Our ref: L.A11230.003.StPhilipsCC-RTS.docx

RE: RESPONSE TO SUBMISSION - ST PHILIP'S CHRISTIAN COLLEGE, CESSNOCK SSDA

Table 1.1 Response to Submission

Drawing:
C-8

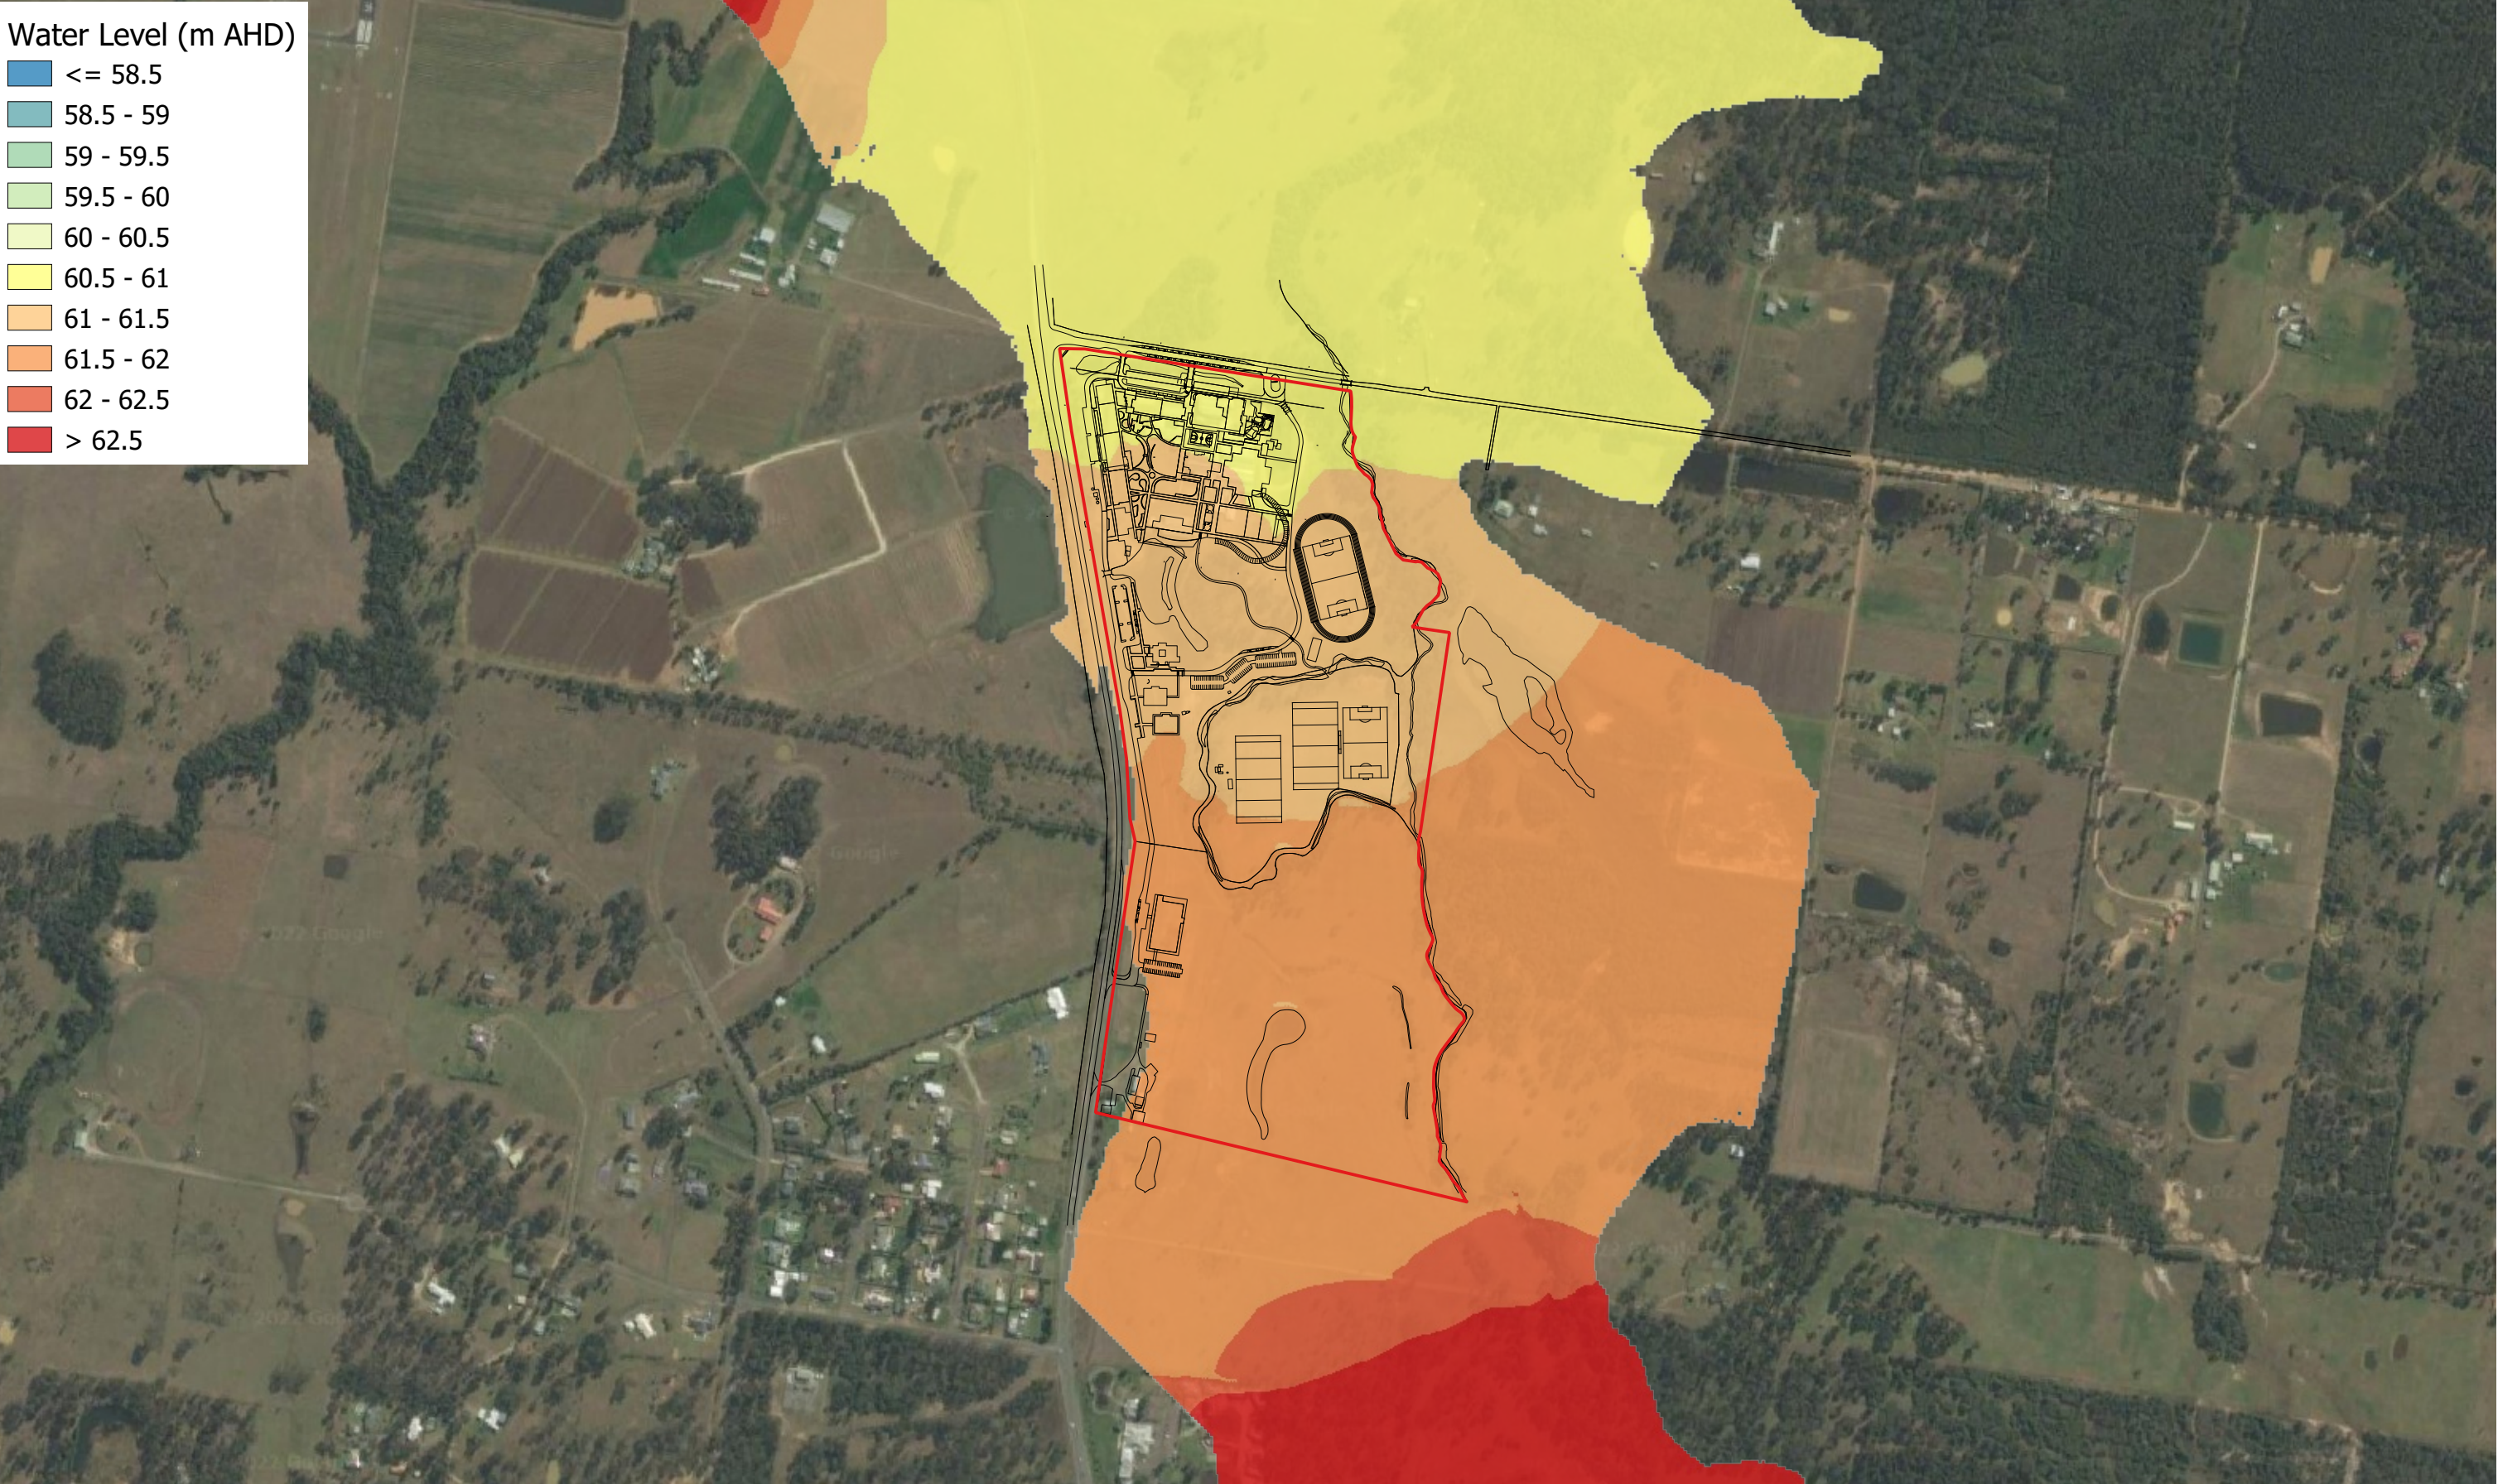
<i>• the Department requests that the existing arrangements for evacuating school students be analysed and the future evacuation methods be provided in detail and compared to the existing evacuation methods. It should be noted that the school students will not be able to self-evacuate. Consequently, the FERP must include analysis of scenarios where parents would arrive to pick up children prior to a flood event impacting access routes to the site and what impact that would have on the surrounding roads.</i>	BMT has prepared an updated Flood Emergency Response Plan (FERP) for the Site which assessed feasible evacuation routes and recommended early evacuation as the primary flood emergency response strategy. Detailed arrangements for the full evacuation of the Site are included in the updated FERP. Also attached herein is the Traffic Engineer's commentary on the feasibility of the FERP.
<i>• Council's submission raised concern that the Council's mapping of flood prone land differs to that shown in the submitted FIA. The Department requires you to address Council's concerns as part of a revised FIA, including the following matters:</i> <i>○ no structures are permitted within the floodway.</i> <i>○ on-site refuge during flood events is not supported.</i> <i>○ flood free access is not demonstrated for a 1% AEP.</i> <i>○ flood water is shown to increase by 20-50mm along the eastern boundary of Lot 892 DP 574957.</i>	As per previous responses for Cessnock City Council
